Access Compliance Report

Public Rights-of-Way

Intersection ID: 44011	Main Street: AVONHURST_LN	Cross Street: BRADWELL_DR	Location: S
ADA ID: 01DBFF8B8604	Ramp Type: PerpDiag	Initial Pass/Fail: Fail	Overall Compliance: No
		Severity Score: 8.75

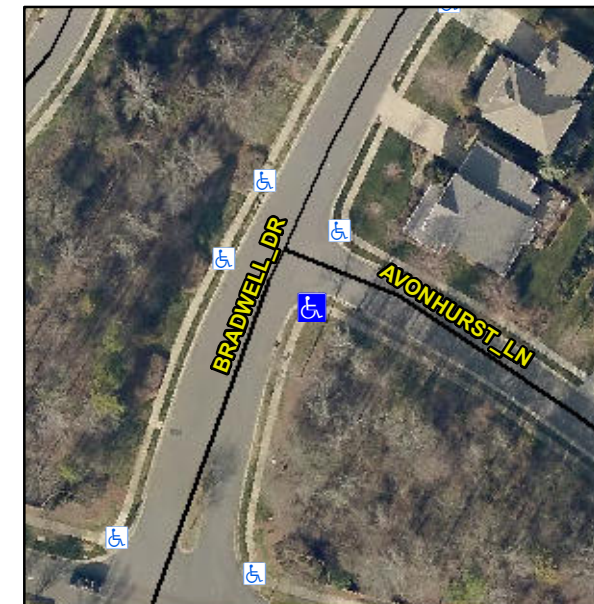
R304.5.1

Compliance	Description	Data	Compliance	Description	Data
N/A	Ramp Length (in)	51.0	Yes	Ramp Slope (%)	7.4
No	Ramp Width (in)	36.0	Yes	Ramp XSlope (%)	0.3
N/A	Flare Type LT	N/A	N/A	Flare Type RT	N/A
N/A	Flare Slope LT (%)	N/A	N/A	Flare Slope RT (%)	N/A
N/A	Flare Traversable LT?	N/A	N/A	Flare Traversable RT?	N/A
N/A	Landing Length (in)	N/A	N/A	DWS Provided?	N/A
N/A	Landing Width (in)	N/A	N/A	DWS Contrast?	N/A
N/A	Landing Slope (%)	N/A	N/A	DWS Length (in)	N/A
N/A	Landing X Slope (%)	N/A	N/A	DWS Full Width?	N/A
N/A	Landing Curb? (Y/N)	N/A	N/A	DWS Offset (in)	N/A
N/A	Shared Landing?	N/A			
N/A	Gutter Ponding?	N/A	N/A	Gutter Slope (%)	N/A
N/A	Gutter Lip Ht (in)	N/A	N/A	Gutter X Slope (%)	N/A
N/A	Painted X Walk1?	No	N/A	Painted X Walk2?	No
	X Walk 1 Direction	To NE		X Walk 2 Direction	To NW
N/A	X Walk 1 Width (in)	N/A	N/A	X Walk 2 Width (in)	N/A
	X Walk 1 Slope (%)	3.1		X Walk 2 Slope (%)	1.4
	X Walk 1 X Slope (%)	1.4		X Walk 2 X Slope (%)	3.6

Remove & Replace Curb Ramp With Two New Directional Ramps or Equivalent.
